Title - Sujet CCGS Terry Fox VLE	
Solicitation No. - N° de l'invitation F7049-200041/B	Amendment No. - N° modif. 005
Client Reference No. - N° de référence du client F7049-200041	Date 2021-11-28
GETS Reference No. - N° de référence de SEAG PW-\$\$MD-043-28394	
File No. - N° de dossier 043md.F7049-200041	CCC No./N° CCC - FMS No./N° VME
Solicitation Closes - L'invitation prend fin at - à 02:00 PM Eastern Daylight Saving Time EDT on - le 2022-04-14 Heure Avancée de l'Est HAE	
F.O.B. - F.A.B. Plant-Usine: <input type="checkbox"/> Destination: <input type="checkbox"/> Other-Autre: <input type="checkbox"/>	
Address Enquiries to: - Adresser toutes questions à: Pandini, Madeleine	Buyer Id - Id de l'acheteur 043md
Telephone No. - N° de téléphone (873) 353-9119 ()	FAX No. - N° de FAX () -
Destination - of Goods, Services, and Construction: Destination - des biens, services et construction:

Solicitation Amendment # 5

- 1. To include Questions and the Responses for the solicitation.**
- 2. To provided updates to Annex A - Statement of Work (SOW)**

Figure 1 Proposed Tween Deck Location

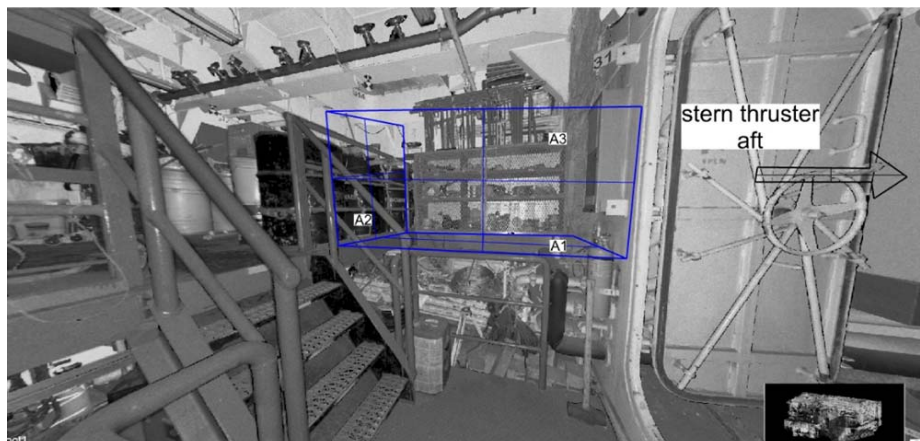
- Add section 3.2 and subsections 3.2.1.1 to 3.2.1.6:
 - 3.2 Installation of Tween Deck Section in Aft Cargo Hold**
 - 3.2.1.1 The Contractor is to fabricate and install a new section of Tween-deck decking to accommodate the installation of the new High Pressure Local Application Water Mist Firefighting System (LAFFS) (reference Specification 10.7).

- 3.2.1.2 The new deck section is to be fabricated and installed as per ABS Rules, MSI drawing 2365-01-00 entitled CCGS Terry Fox Cargo Hold Tween Deck Structure Arrangement supply for reference. See Figure 1 Proposed Tween Deck Location for more information.

- 3.2.1.4 Once the new deck section has been installed it is to be surrounded on three (3) sides with a half wall sections as per Figure 1 below. Half wall sections are to be fabricated from six (6mm) minimum and secured in place.

- 3.2.1.5 The Figure 1 below shows the location and proposed layout of the of new tween deck extension with the following legend:
 - A1 New deck Section (approx. 2000 mm x 1400 mm)

- A2 Added half wall in transverse direction (approx. 1800 mm tall x 1400 mm)

- A3: Added half wall in longitudinal direction (approx. 1800 mm tall x 2000 mm)
